UNITED STATES PATENT AND TRADEMARK OFFICE

APPLICATION NO.	FILING DATE	FIRST NAMED INVENTOR	ATTORNEY DOCKET NO.	CONFIRMATION NO.
10/820,186	04/07/2004	Thomas R. Marsh	9066-23DV	7421
20792	7590	12/14/2004	EXAMINER	
MYERS BIGEL SIBLEY & SAJOVEC PO BOX 37428 RALEIGH, NC 27627			LUGO, CARLOS	
			ART UNIT	PAPER NUMBER
			3676

DETAILED ACTION

Attachment #1

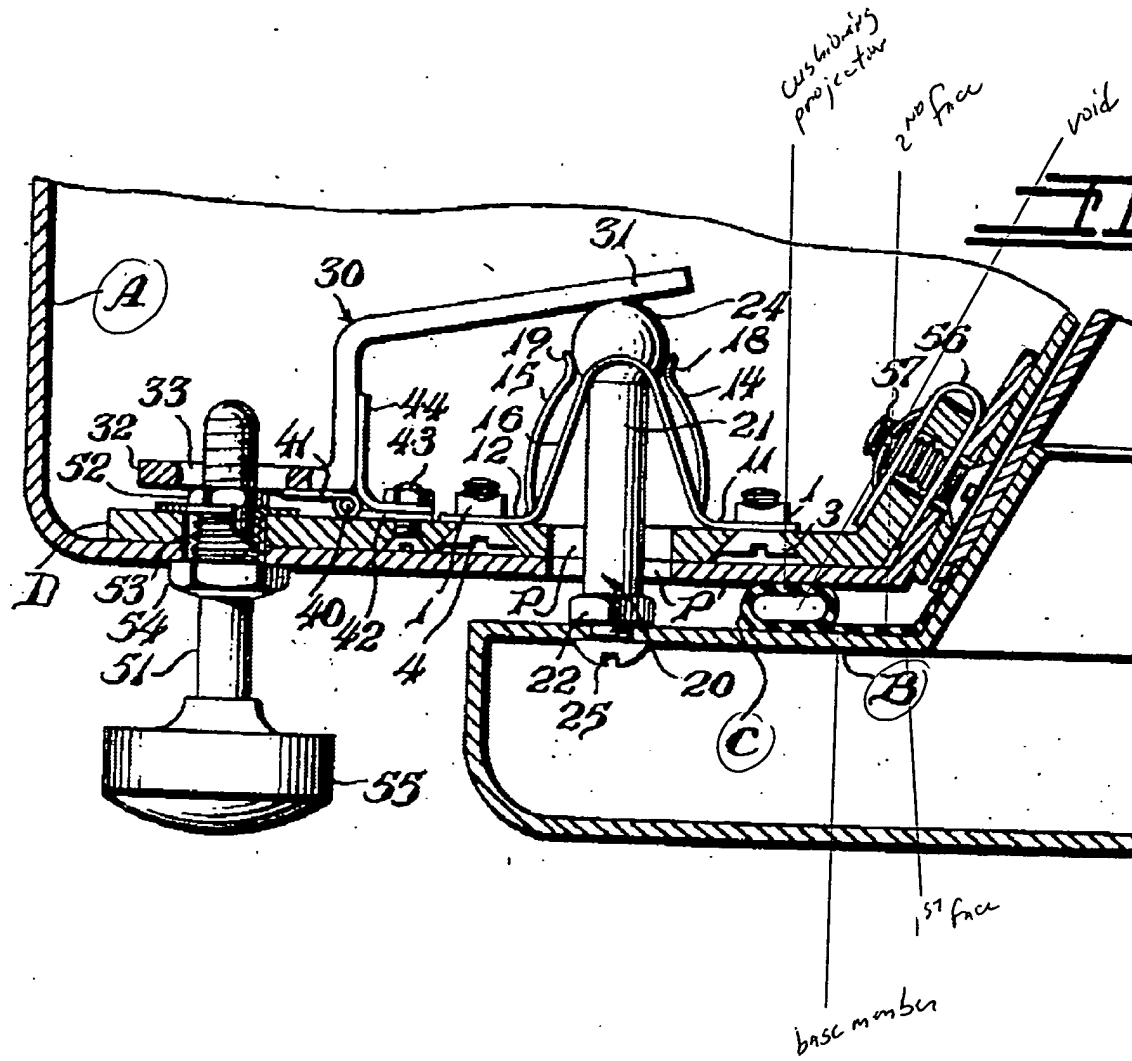
Regarding claim 1, Tinnerman discloses a device (C) for protecting first and second confronting furniture components (A and B).

The device comprises a base member having opposite first and second faces (see Attachment #1). The first face is adapted to contact the first furniture component (B). The base member has a cushioning projection extending outwardly from the second face of the base member and covering and defining a void within the base member (Figures 1 and 2, see Attachment #1). The projection is adapted to contact the second furniture component (A) as it confronts the first furniture component.
